Exterior Mirror Corrosion

Classification	Repair Bulletin	Section/Group	12 - Exterior Fittings	Country/Region	North America and Europe
Year	2012-2014	Model	Model S	Version	All

This Service Bulletin supersedes SB-14-12-003, dated 15-Sep-14. Each content change is marked by a vertical line in the left margin. Discard the previous version and replace it with this one.

Figure 2

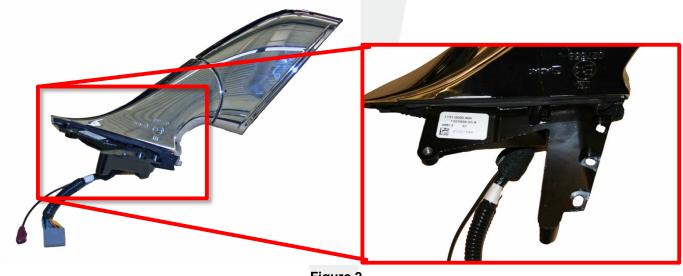
The aluminum casting on some exterior mirrors might experience corrosion in cold climates, causing white residue to drip onto the door panels, creating a perceived quality issue. Updated mirrors are now available with e-coated frames that prevent corrosion.

5. Inspect the replacement mirrors to ensure that the aluminum casting has black e-coating (Figure 2).

Upon customer complaint, replace both exterior mirrors. Remove residue from the mirror frame and door interior, if necessary.
